SUBDIVISION / LAND DEVELOPMENT PLAN APPLICATION

PROJECT NAME (TO BE COMPLETED BY TOWNSHIP): The Farmhouse

PRELIMINARY / FINAL LAND DEVELOPMENT PLANS 4000 LINCOLN HIGHWAY CALN TOWNSHIP * CHESTER COUNTY * PENNSYLVANIA

The Plan proposes construction of a restaurant with a drive-through, parking areas and subsurface stormwater infiltration beds.

EMERGENCY VEHICLE TURNING TEMPLATE
NOT TO SCALE

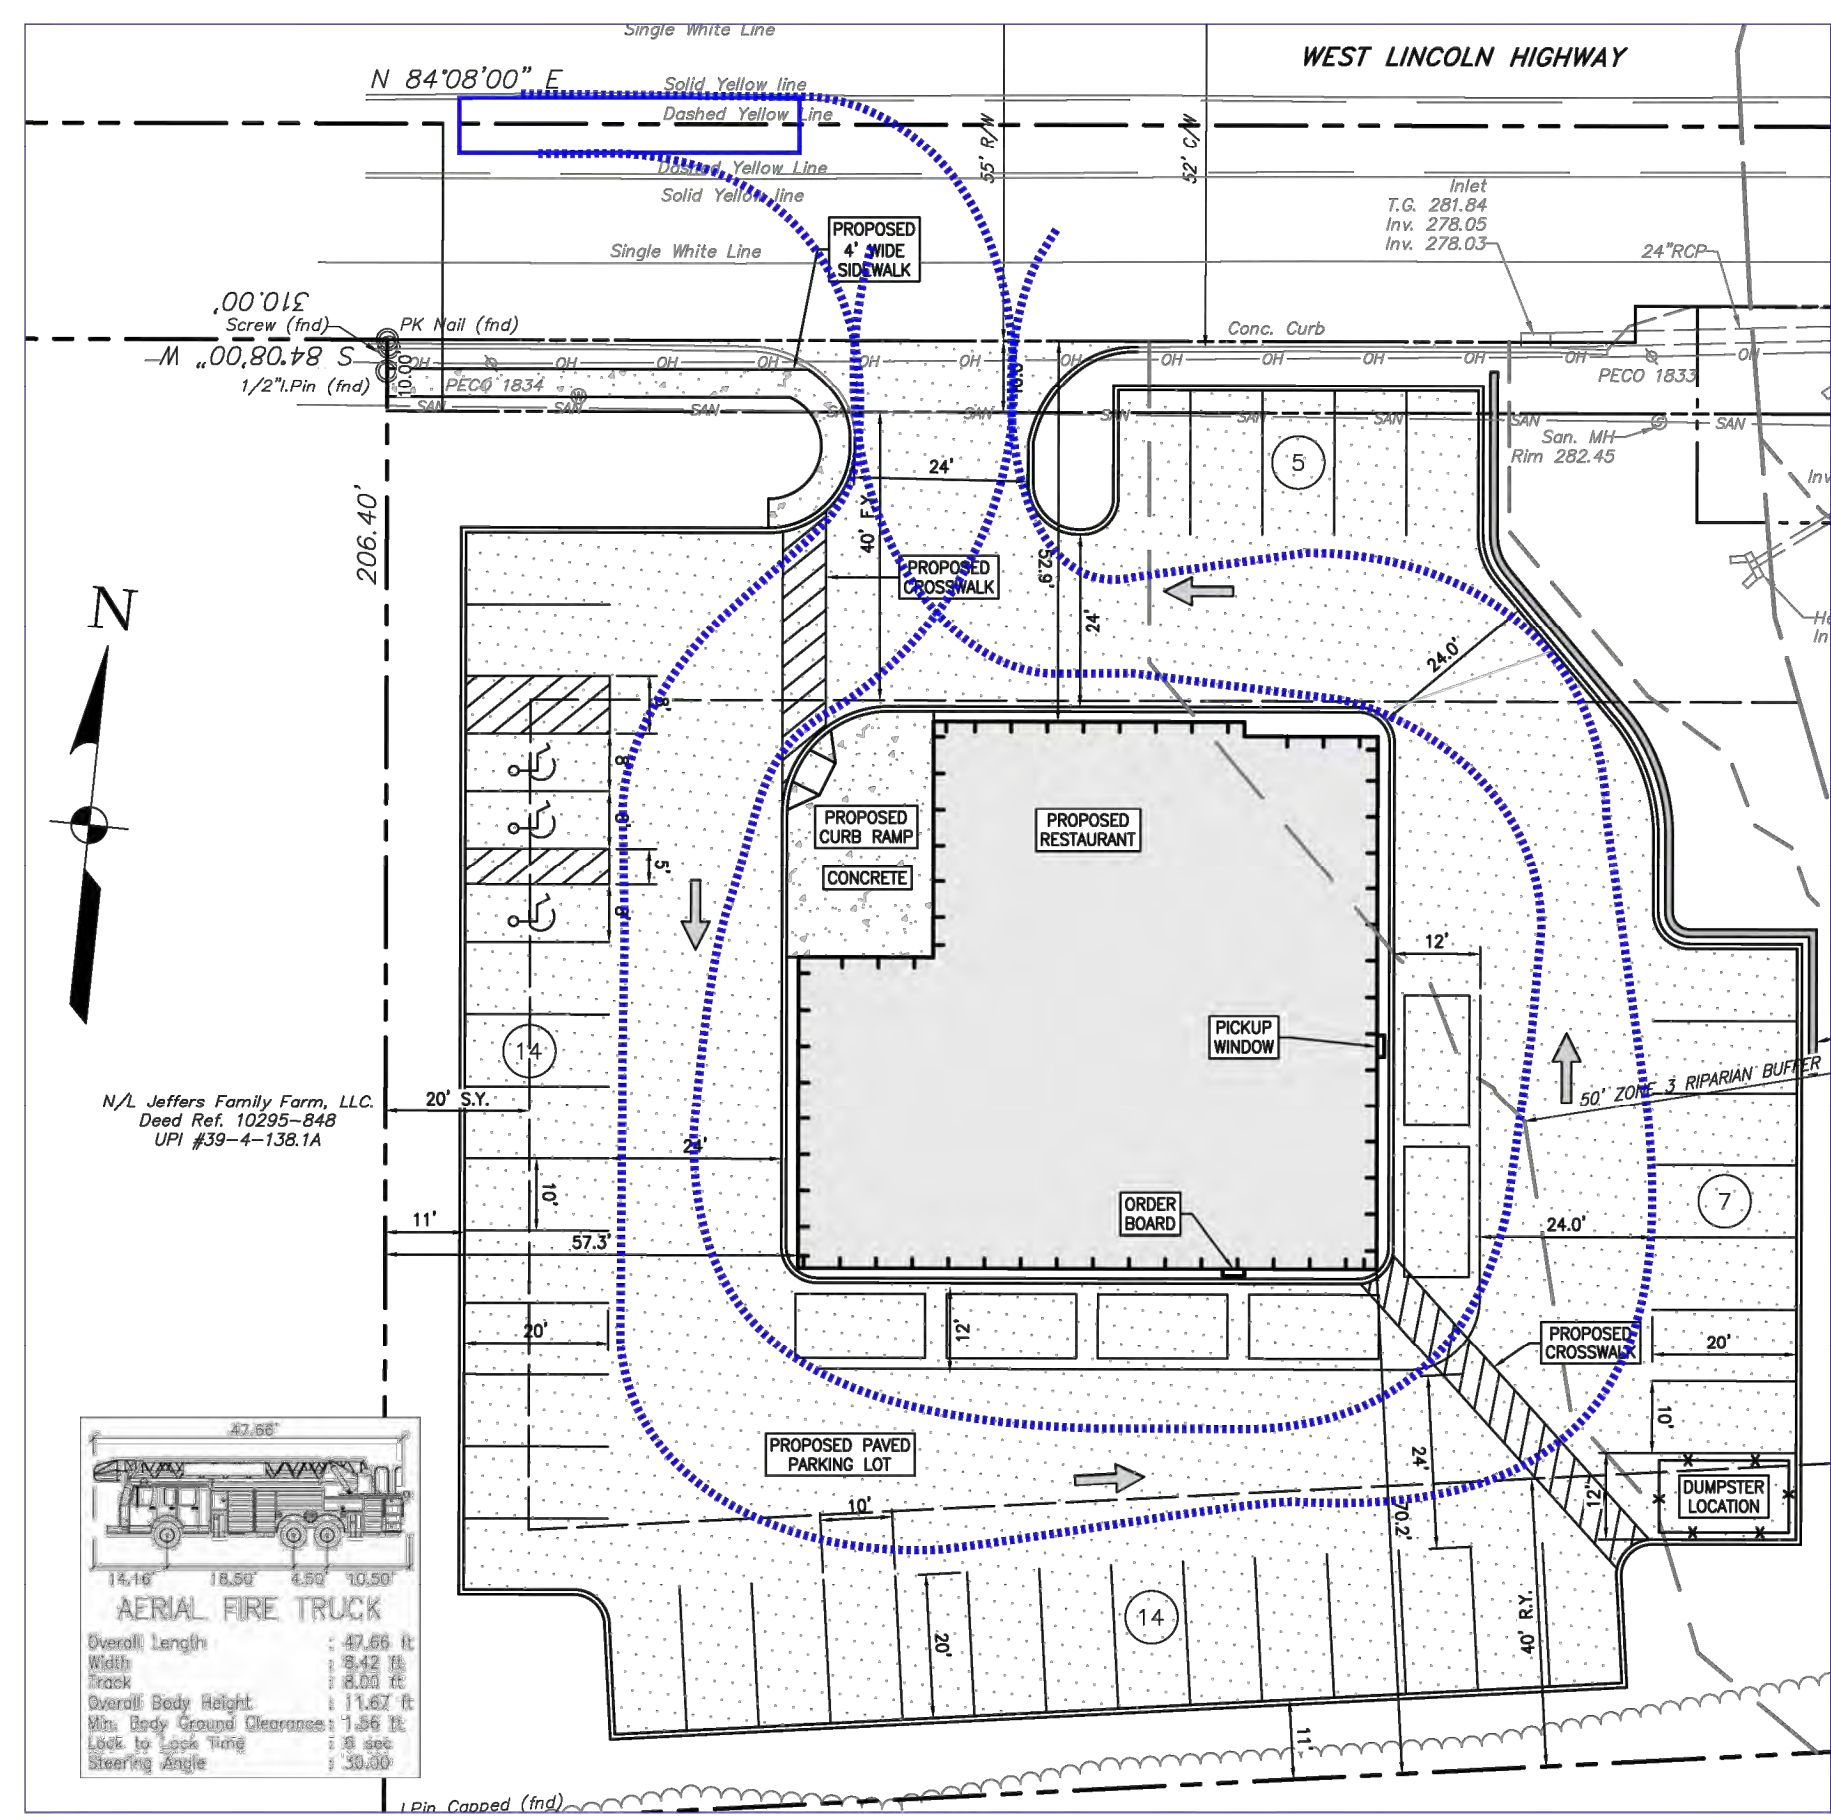
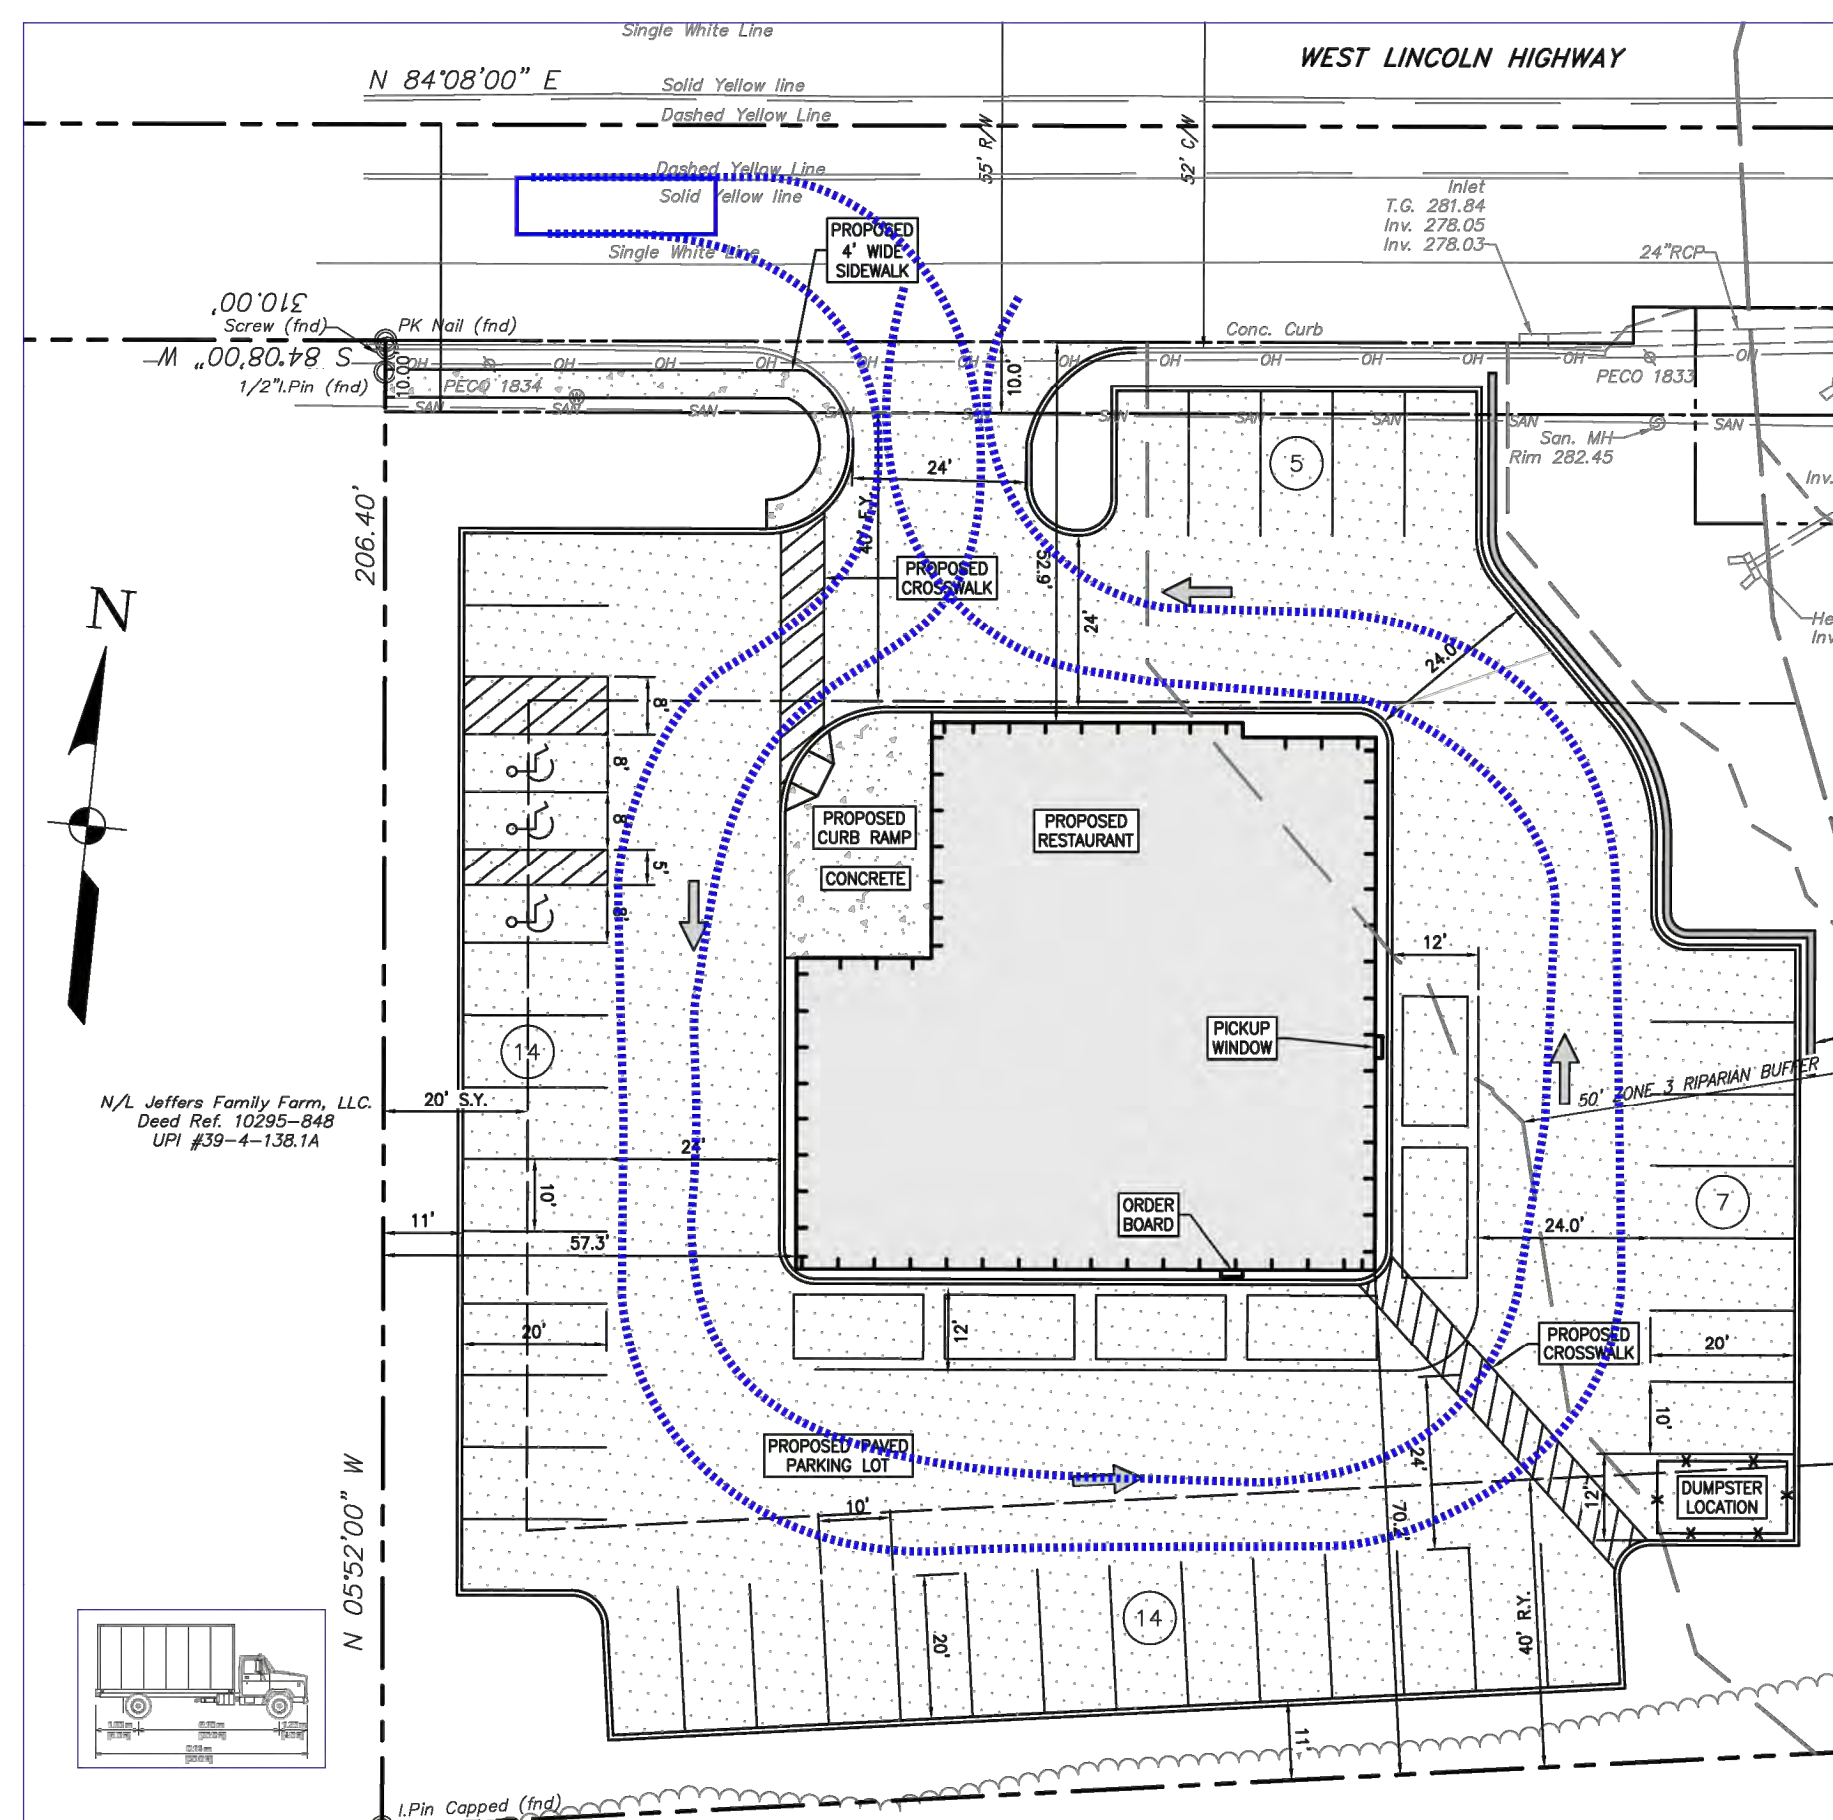
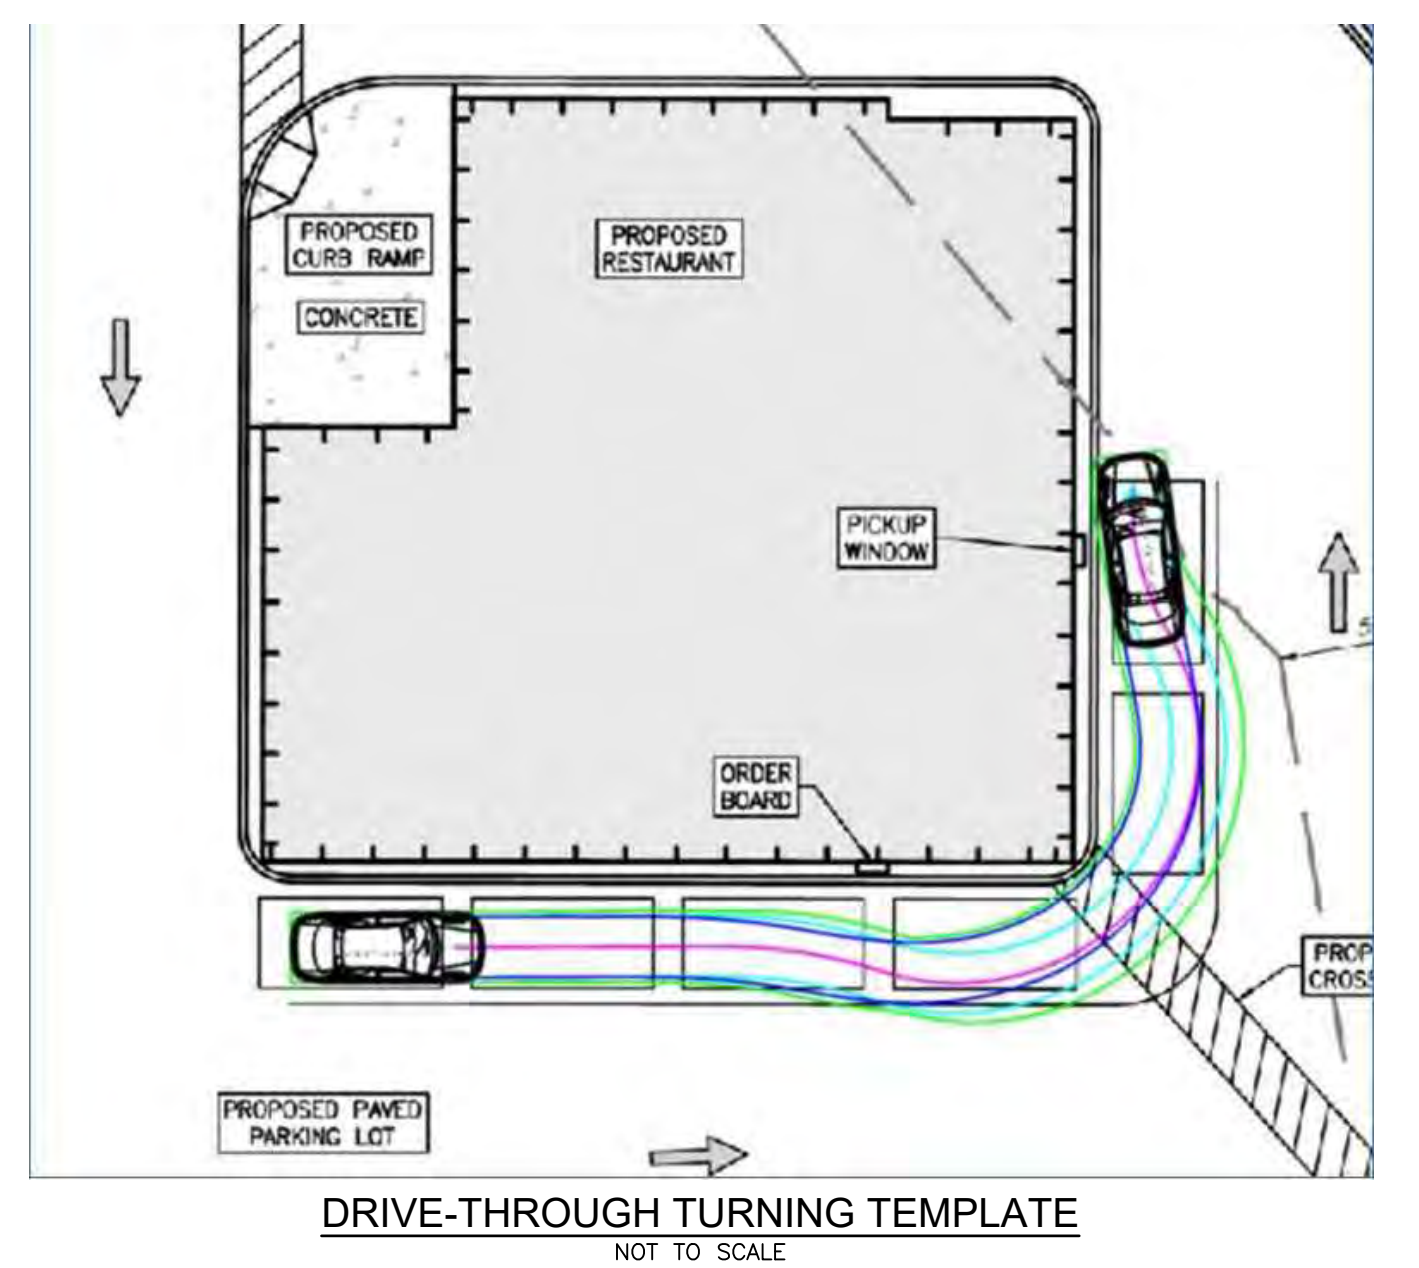
The vehicle details provided on sheet 10 are not legible. The drive-through turn template appears to show that it will be difficult for drivers to reach the pickup window without additional guidance around the corner of the building. Applicant may consider moving the order board or pickup window or adding paint lines, bollards and/or markers to the drive-through lane to guide vehicles into appropriate positions at the order board and pickup window.
